PROJECT NAME:		
ARM C SITE RENOVATIONS PLAN		
REVISIONS		
No.	DATE	DESCRIPTION
1	10.28.05	ADD NARRATIVE and VG on MLK
SHEET TITLE:		
OVERALL SITE GRADING PLAN		
DESIGNED: DAA	SCALE: 1"=30'	
CHECKED: DAA	JOB NO: 4031	
DATE: 8-5-05	COMP. FILE: 4031-C2.1

C2.1
OCT 3 1 2005
HYDROLOGY SECTION

PROPOSED SITE GRADING PLAN
SCALE: 1" = 30' (22X34)
SCALE: 1" = 60' (11X17)

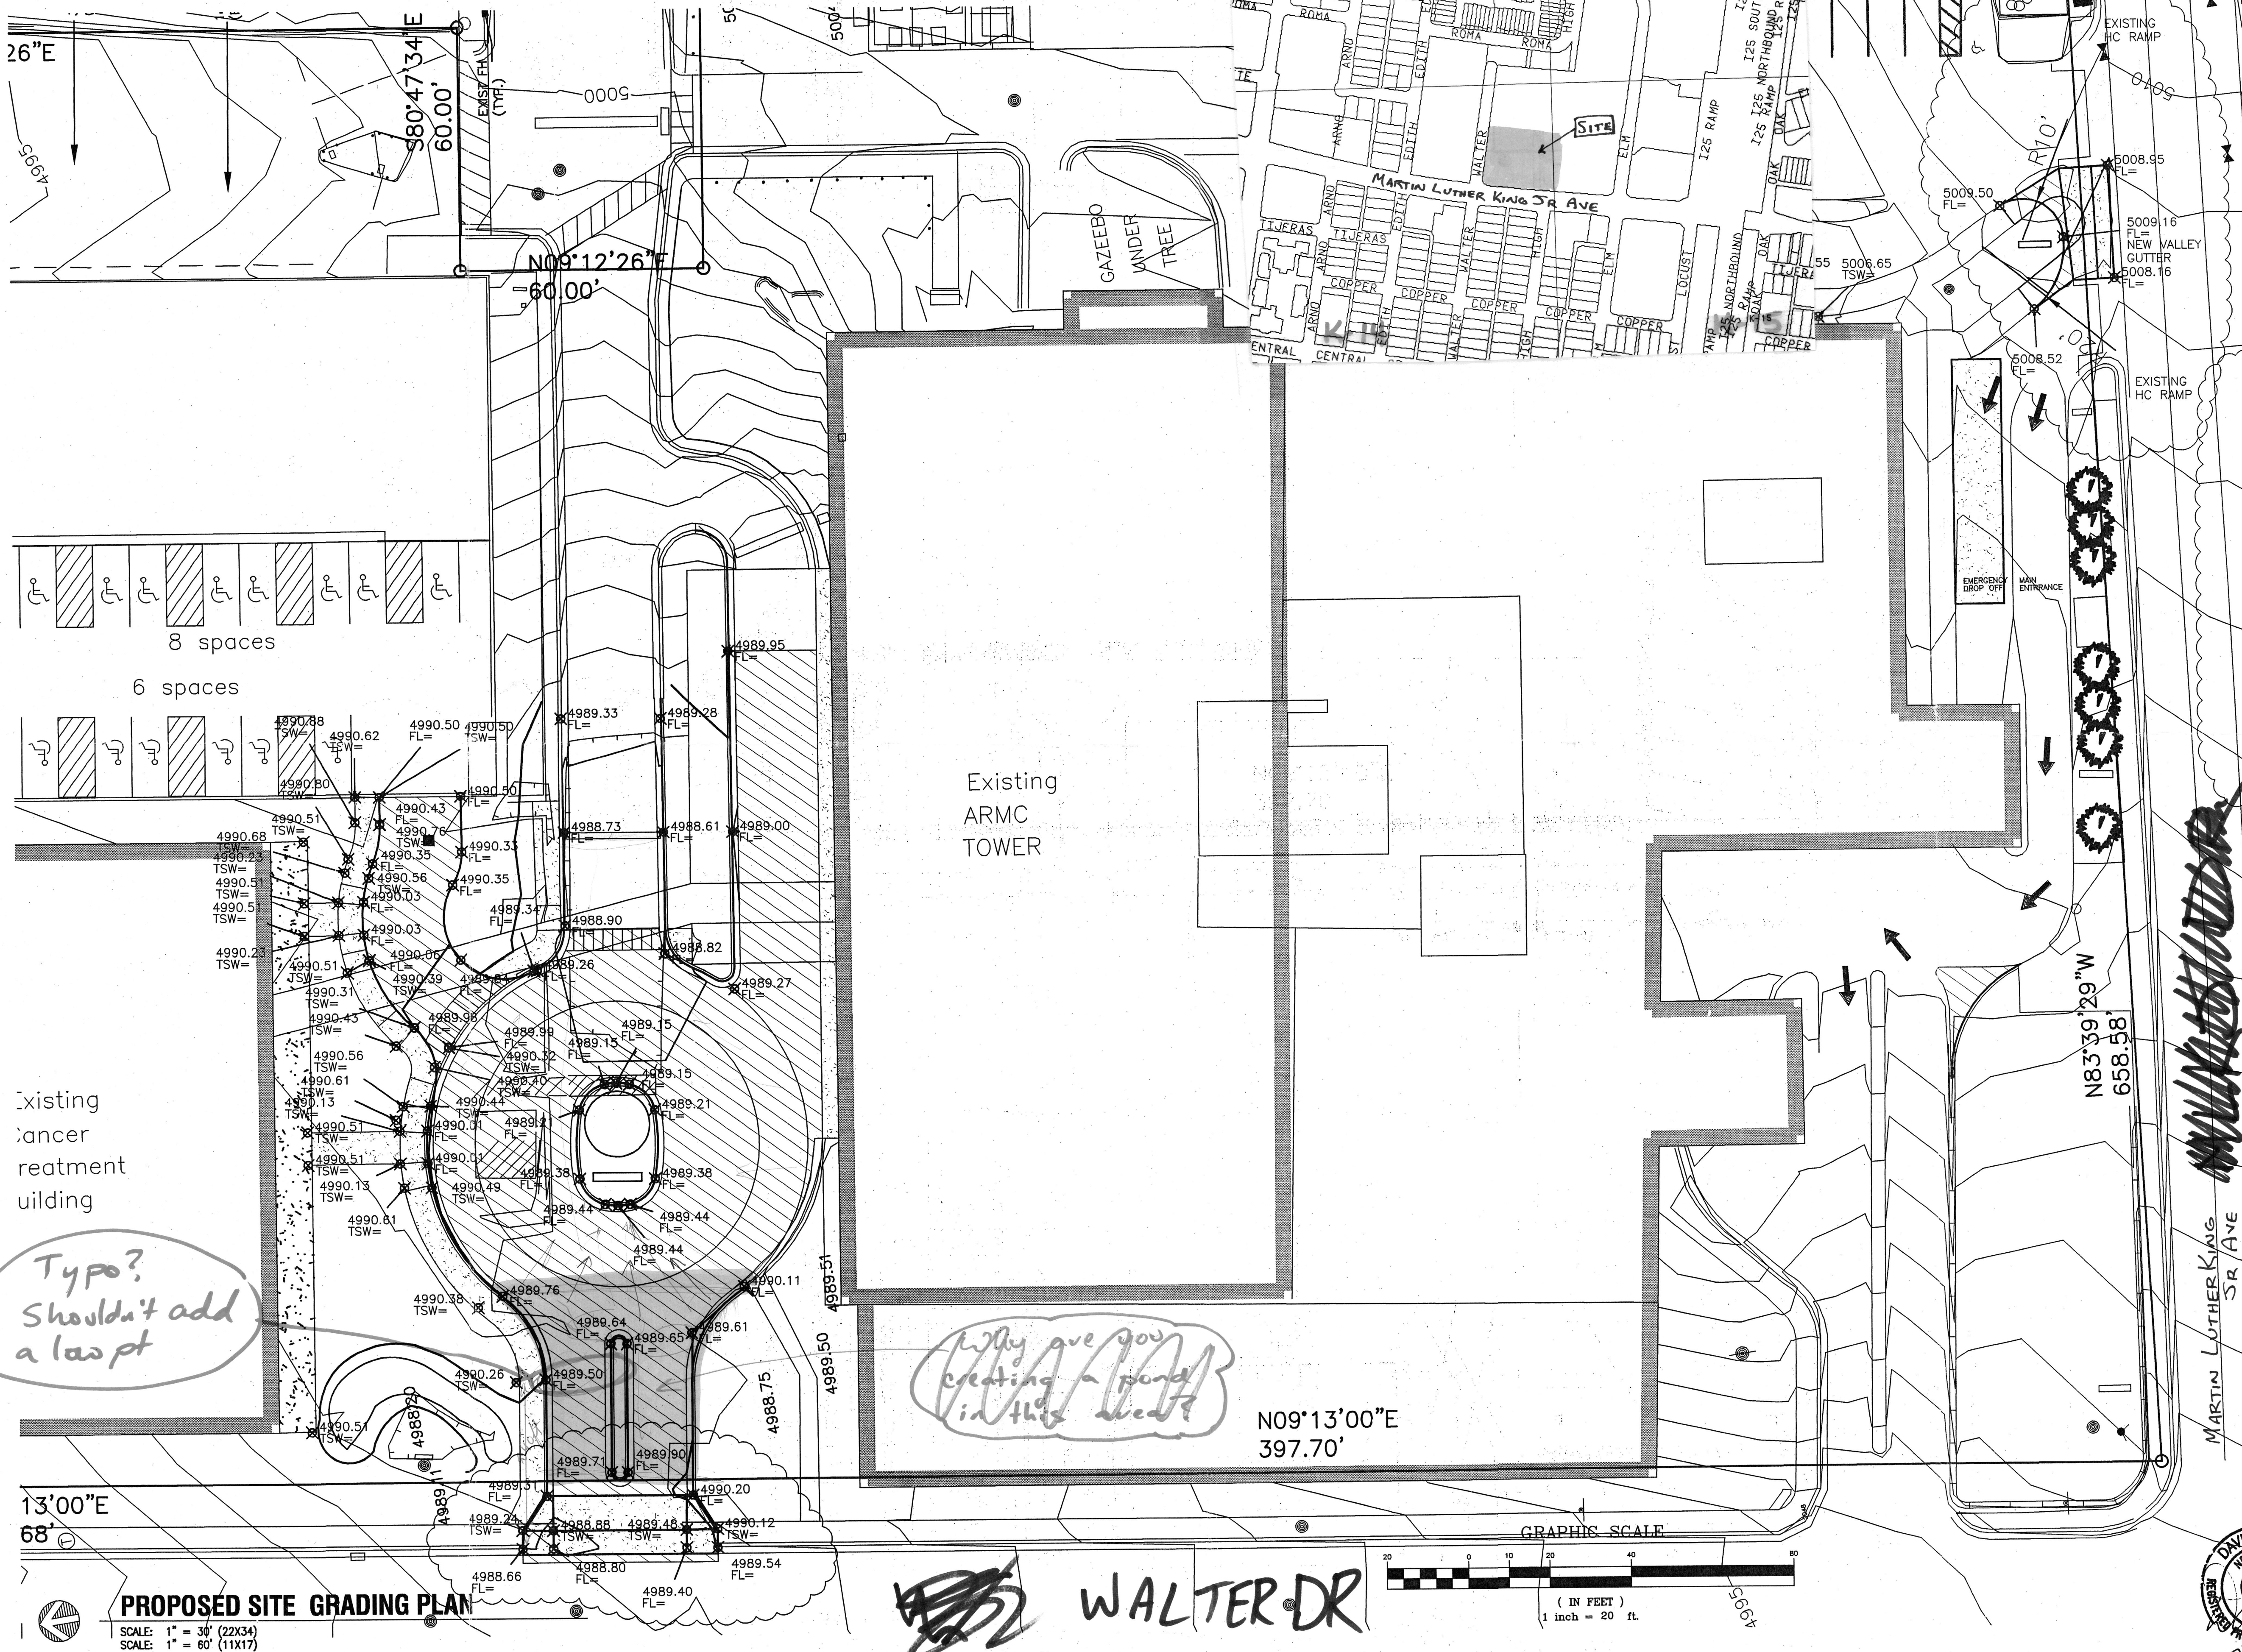
Why give you creating a pond in this sheet?

Typo? Shouldn't add a loop pt
